Planning Supporting Statement : 23 Linksway Notthwood HA6 2XA

Proposed Revisions to Approved Plans & comments received at Pre-Application taken into account

Approved Front Elevation

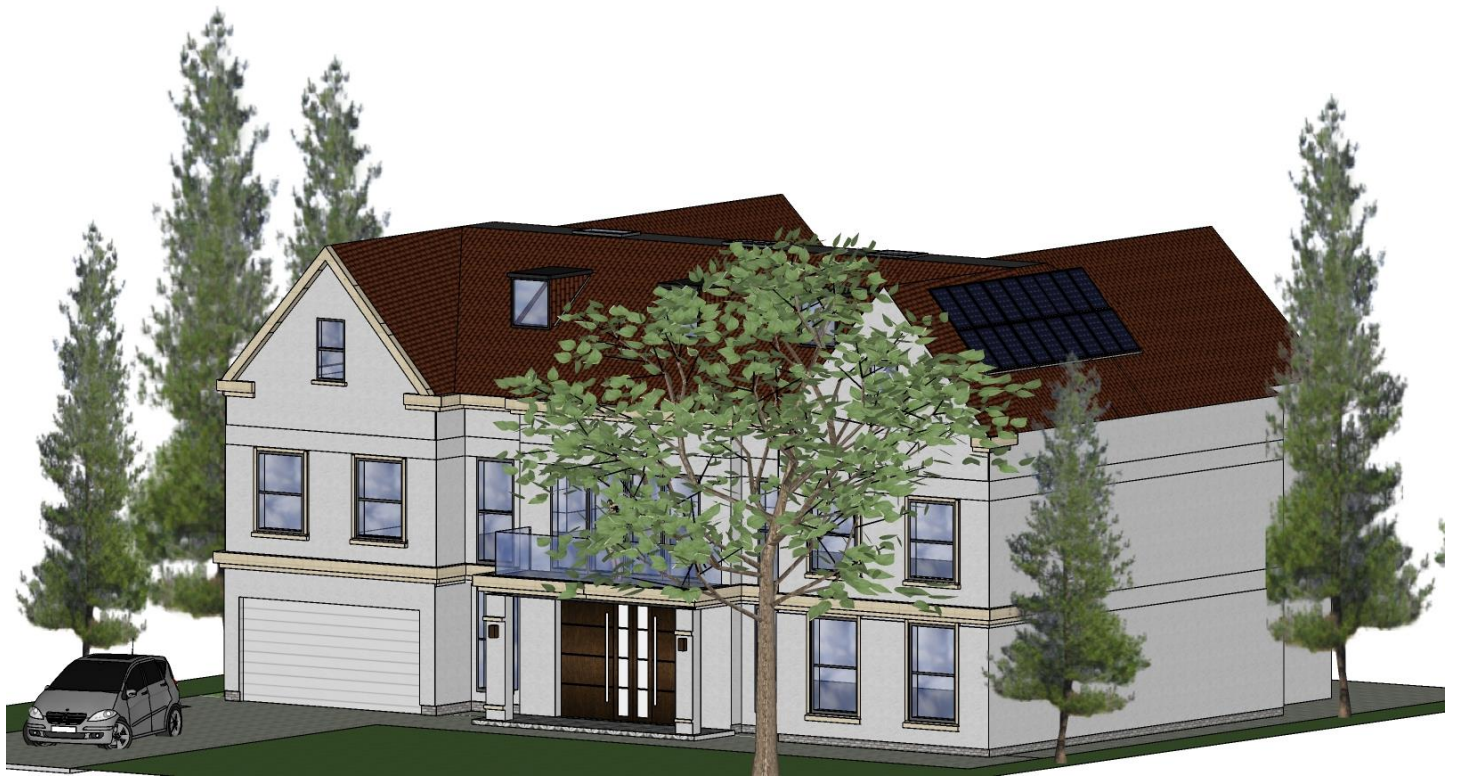
Front Elevation is replace of Brick finish back to original house chalk white render

Suggestion is to Omit Brick Finish as approved,
with white rendered similar to original house (demolished) and adjacent 25 Linksway

The 2nd aspect of Re-modelling is to have gable to the two projected wings.

1. reduce the heavy brickwork bulk that overpowering in a site that is heavy landscape site with many TPO.
2. design that articulates a softer clear elevation reduces bulk allowing the sites mature TPO landscape streetscape to prevail.

We welcomed the support in general at Pre-App meeting discuss our have taken on board the comments related to fully glazed front gable, which has now been omitted with a more traditional front gable with a small feature window that is now in keeping with the front elevation

Remodelled: Glazing Mullions omitted

Front Gable added revised after pre-app meeting comments Proposed Remodelled 3D Visual

Proposed Rear Gable Elevation

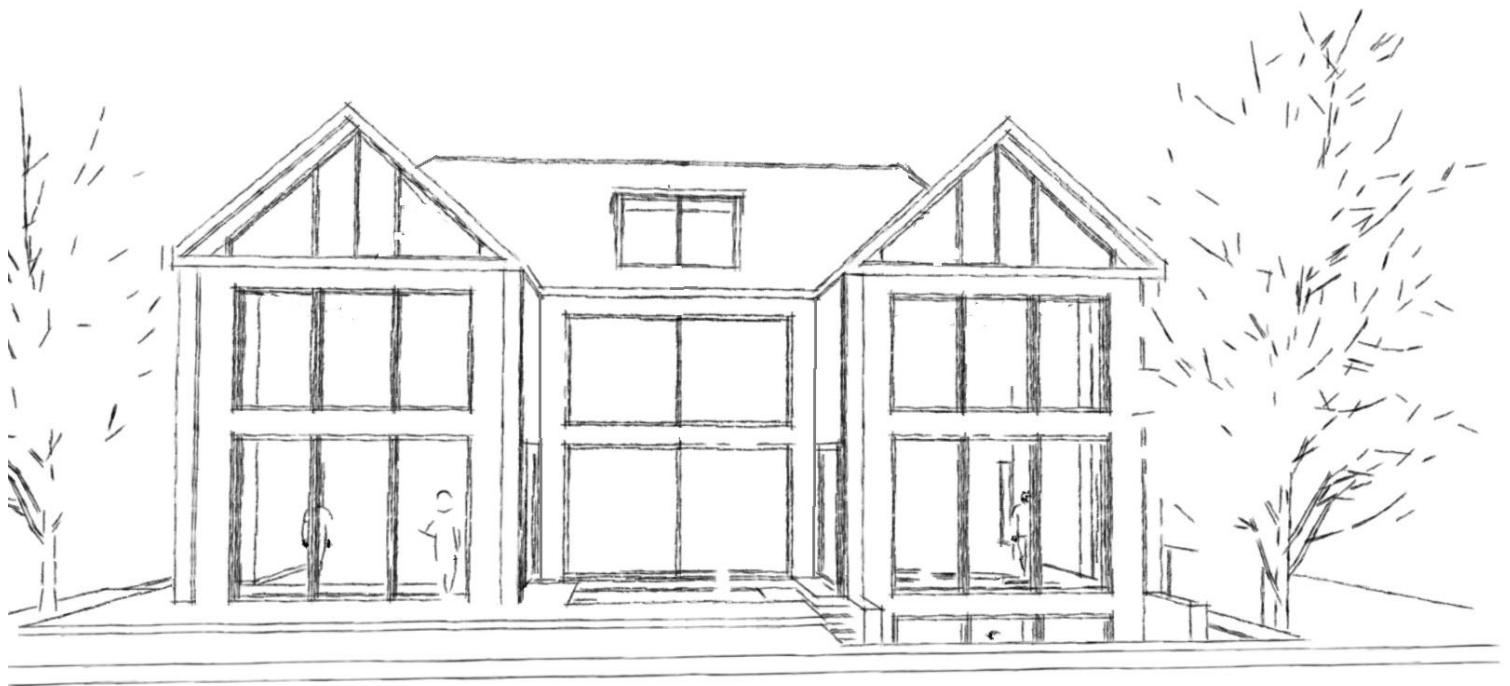
The same approach to remodel is repeated with rear elevation.

Proposed Remodelled gable added and glazing revised
